RAI Volume 4, Chapter 2.4, Second Set, Number 1:

RAI Volume 4, Chapter 2.4, Second Set, Number 2:

Figure 1. Possible Timeline for Implementation of Drip Shield Programs

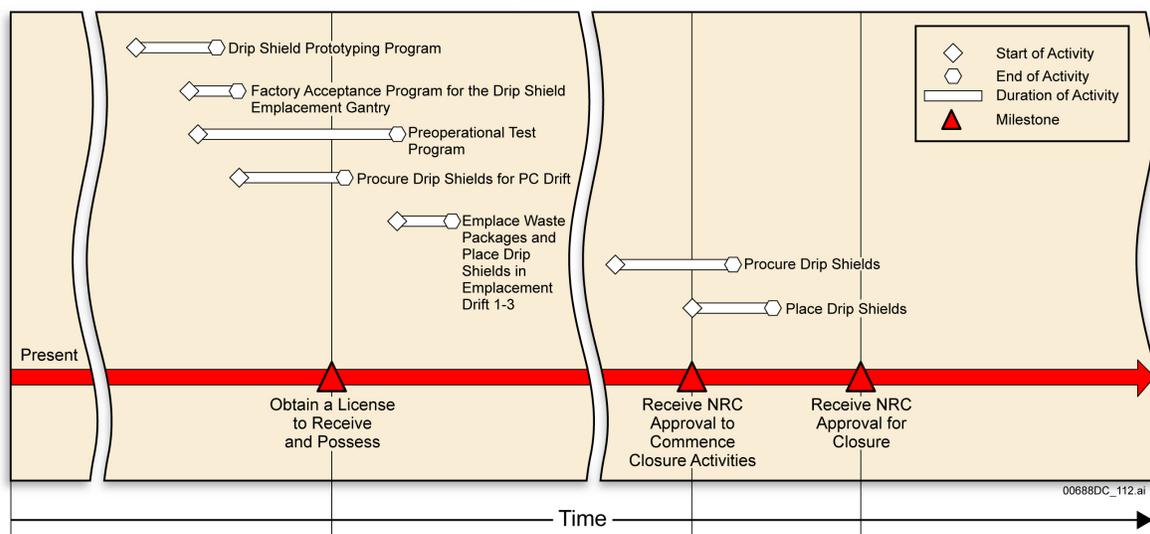
At the clarification call on January 13, 2010, the NRC requested relative schedules for design testing activities and confirmation that drip shields will be installed in the thermally accelerated drift. As communicated at the clarification call, the schedule for Performance Confirmation test plans has been provided to the NRC in the response to RAI 4.2.4-002. Drip shields are expected to be installed in all, or part, of the thermally accelerated drift shortly before ventilation is terminated (SNL 2008, Section 3.4.5). Planning for Performance Confirmation testing within a thermally accelerated drift will be finalized in the Performance Confirmation test plan consistent

Figure 1 illustrates a possible timeline for implementation of these programs and their interdependencies. The drip shield prototyping program and factory acceptance program for the drip shield emplacement gantry will begin first and proceed approximately in parallel. The drip shield prototyping program will include testing to ensure that the appropriate postclosure control parameters, assumptions, and performance requirements obtained from the postclosure analyses are satisfied during the fabrication process. This includes demonstration of the interlocking features as well as demonstration of the design capability to meet the requirements related to transportation and handling.
